Access Compliance Report

Public Rights-of-Way

Intersection ID: 49386	Main Street: DAMASCUS_ST	Cross Street: SOUTH_DEVON_ST	Location: SE
ADA ID: 9D63752C5CA9	Ramp Type: Perp	Initial Pass/Fail: Fail	Overall Compliance: No
			Severity Score: 13.75

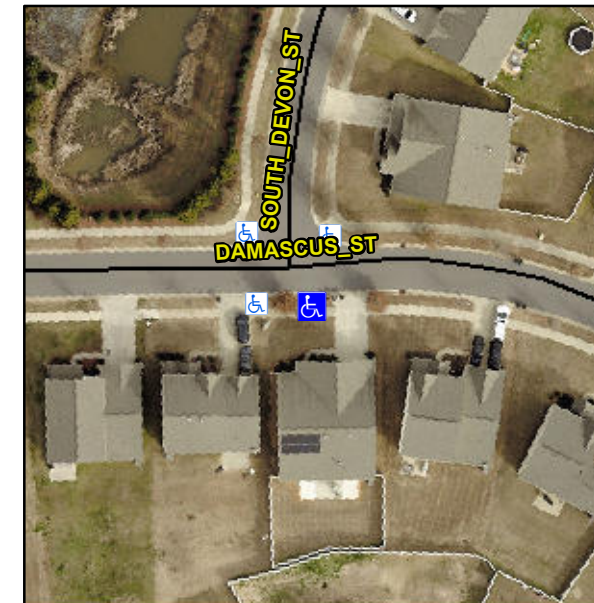
Not Found, R304.2.2

Compliance	Description	Data	Compliance	Description	Data
N/A	Ramp Length (in)	71.0	No	Ramp Slope (%)	8.6
Yes	Ramp Width (in)	48.0	Yes	Ramp XSlope (%)	3.4
N/A	Flare Type LT	N/A	N/A	Flare Type RT	N/A
N/A	Flare Slope LT (%)	N/A	N/A	Flare Slope RT (%)	N/A
N/A	Flare Traversable LT?	N/A	N/A	Flare Traversable RT?	N/A
N/A	Landing Length (in)	N/A	N/A	DWS Provided?	N/A
N/A	Landing Width (in)	N/A	N/A	DWS Contrast?	N/A
N/A	Landing Slope (%)	N/A	N/A	DWS Length (in)	N/A
N/A	Landing X Slope (%)	N/A	N/A	DWS Full Width?	N/A
N/A	Landing Curb? (Y/N)	N/A	N/A	DWS Offset (in)	N/A
N/A	Shared Landing?	N/A			
N/A	Gutter Ponding?	N/A	N/A	Gutter Slope (%)	N/A
N/A	Gutter Lip Ht (in)	0.5	N/A	Gutter X Slope (%)	N/A
N/A	Painted X Walk1?	No	N/A	Painted X Walk2?	N/A
	X Walk 1 Direction	To NE		X Walk 2 Direction	N/A
N/A	X Walk 1 Width (in)	N/A	N/A	X Walk 2 Width (in)	N/A
	X Walk 1 Slope (%)	4.2		X Walk 2 Slope (%)	N/A
	X Walk 1 X Slope (%)	3.5		X Walk 2 X Slope (%)	N/A

Remove & Replace Entire Ramp.
